FINAL DRAINAGE LETTER

**7981 Fort Smith Road
Peyton, CO 80831**

LOT 593 WOODMEN HILLS FILING NO. 9
LOCATED IN SECTION 6, T 13 S, R 64 W OF THE 6TH PM
EL PASO COUNTY, STATE OF COLORADO

Original Submittal: April 10, 2024

Cross Section for Section 0+25 - 5yr

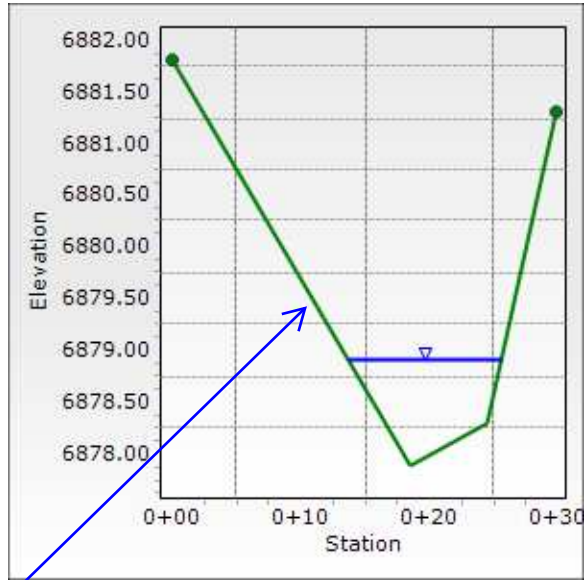
Please label all slopes
(typ throughout the report)
Side slopes for
grass-lined channels shall
be no steeper than 4H:1V
